COA (SP) 2026-017  
May 21, 2026

**STAFF REPORT  
SPECIAL CERTIFICATE OF APPROPRIATENESS  
FOR THE PROPERTY AT  
1008 ALHAMBRA CIRCLE  
A CONTRIBUTING RESOURCE WITHIN  
THE ALHAMBRA CIRCLE HISTORIC LANDMARK**

- Proposal:** The application requests design approval for additions and alterations to the residence and sitework.
- Architect:** Locus Architecture, Inc. (Nelson de Leon, AIA)
- Owner:** Alexander and Lindsay Volsky
- Legal Description:** Lot 9 and the North 45 Feet of Lot 10, Block 4, Coral Gables Section "C," according to the Plat thereof, as recorded in Plat Book 8, at Page 26, of the Public Records of Miami-Dade County, Florida.
- Site Characteristics:** The property is located at the southwest corner of the intersection of Alhambra Circle and Granada Boulevard, immediately adjacent to the Granada Plaza. The lot dimensions are 126.67' x 150'.

**Figure 1: 1940s photo**

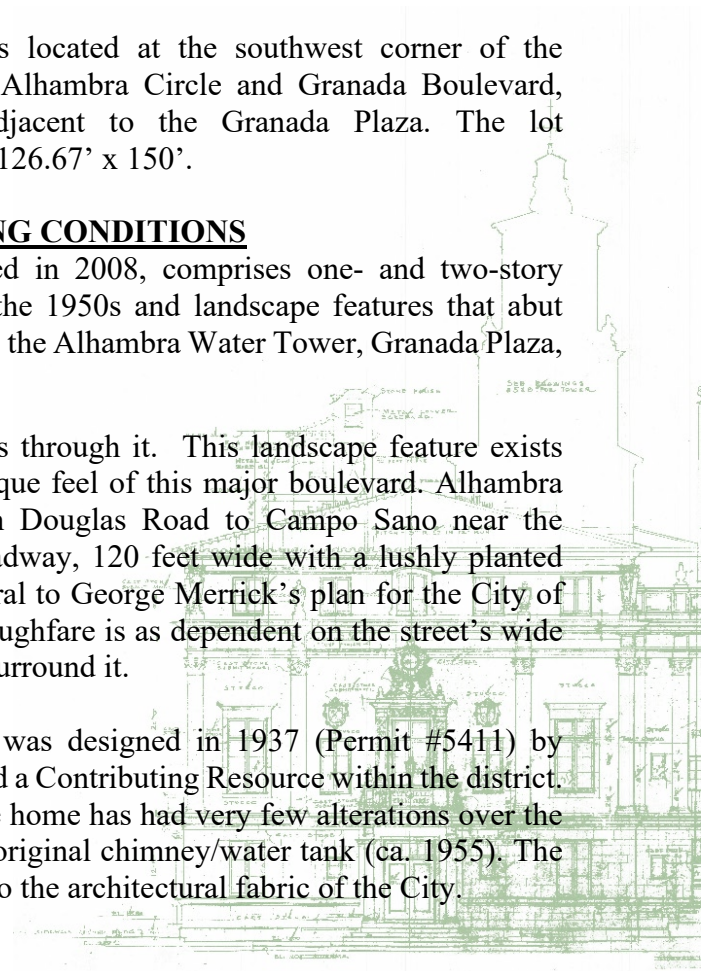
Similarly, the round vents at the second-floor eaves (see Figure 1 and Figures 3) are original details and are to remain. They are shown in the existing elevation, but not the demo or proposed. They remain shown on the other proposed elevations, so this is believed to be a drafting error. Stucco score lines at the banks of windows on the east end of the house are not shown and are original to remain as well.

9. Round vents at the second-floor roof eaves are to remain.
10. Clarify the design intent for the front door.
11. Clarify the proposed stucco texture of the additions.
